SAFETY RECALL BULLETIN

NHTSA RECALL 19V922

AUTOCAR, LLC SAFETY RECALL ACTT-2002

This document provides work instructions for the installation of a ribbed retainer plate inside the cab fuse box.

Figure 1

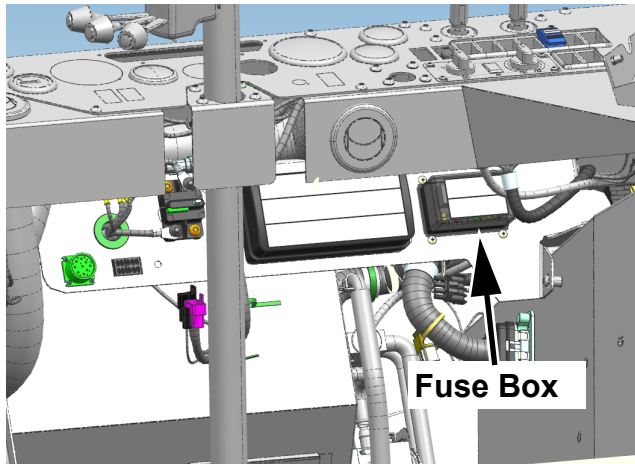
1. Locate the cab fuse box (see Figure 1).

Figure 2

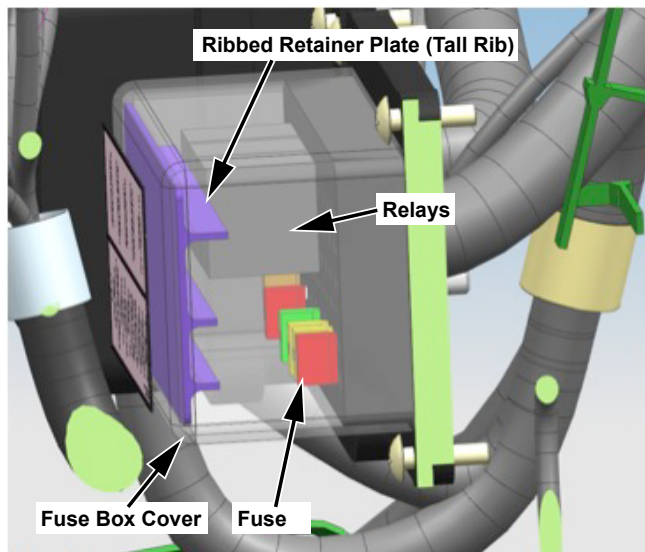
2. Remove the cover from the cab fuse box (see Figure 2).

Figure 3

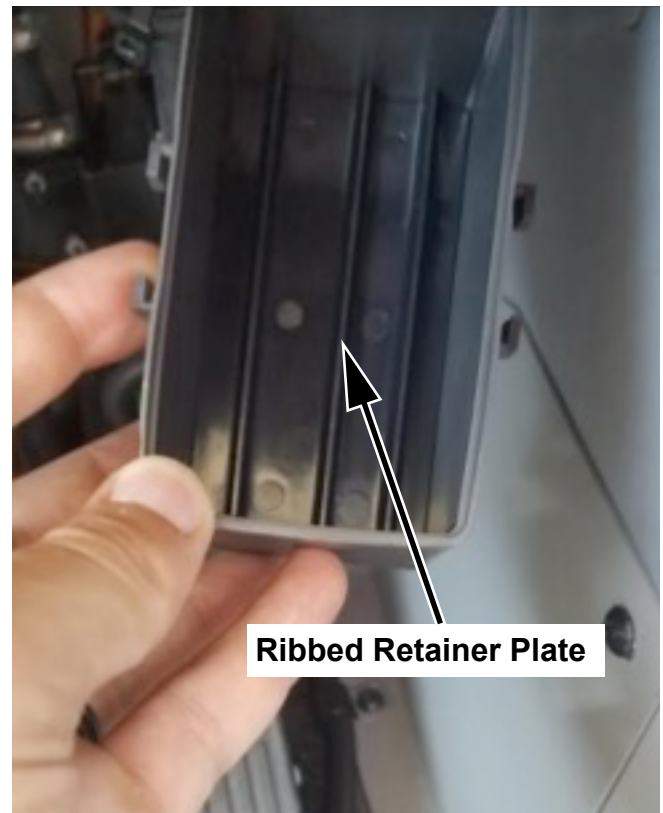
3. Peel off the protective backing from the ribbed retainer plate (A8701012-001), exposing the adhesive.
4. Press the ribbed retainer plate onto the inside top of the fuse box cover. The tall rib should be over relay not fuses (see Figure 3).
